Special Coverage Adjustment

N182188250 Loss of Continuity within Accelerator Pedal Position Sensor Circuit

Release Date: August 2019

Revision: 02

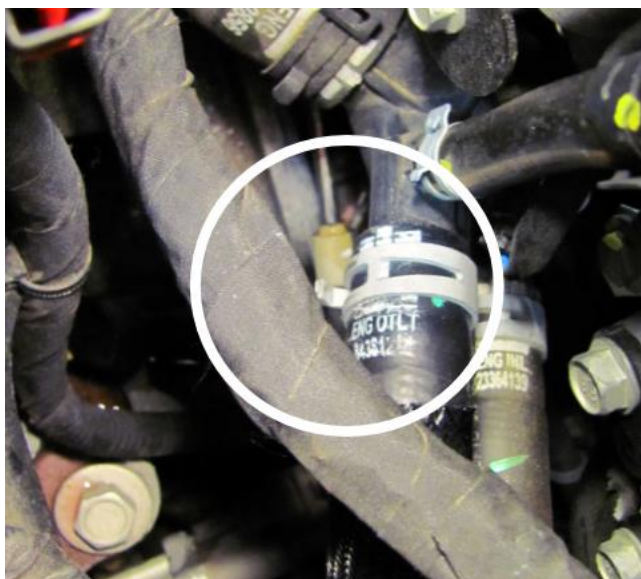
2. On Malibu (LFV engine) applications **only**, inspect the engine wire harness adjacent to the heater inlet hose for contact with the heater inlet hose clamp on the engine outlet portion of the hose as shown.

3. If contact is observed between the heater hose clamp and the engine wire harness, attempt to rotate the heater hose clamp tabs away from the engine harness, ensuring the clamp stays within the alignment guide markings.

- If the heater inlet hose clamp is **not** glued to the heater inlet hose, rotate the heater inlet hose clamp so the tabs are facing away from the engine wire harness. Ensure the clamp stays within the alignment guide markings. There should be at least 3/4 inch (19mm) of clearance between the heater hose clamp tabs and the engine wire harness.

- If the heater hose clamp **is** glued to the heater hose, replace the heater inlet hose and both heater hose clamps, being sure to clock the heater inlet hose clamps so the tabs are facing away from any adjacent engine wire harnesses. Ensure the clamp stays within the alignment guide markings. Refer to *Heater Inlet Hose Replacement (LFV)* in SI.

- If any damage is observed to the engine harness, repair the harness and the affected circuits. Refer to *Wire to Wire Repair* in SI. Rewrap the harness in the affected area with PET tape in addition to clocking the hose clamp away from the harness to ensure another rub-through event is no longer possible.
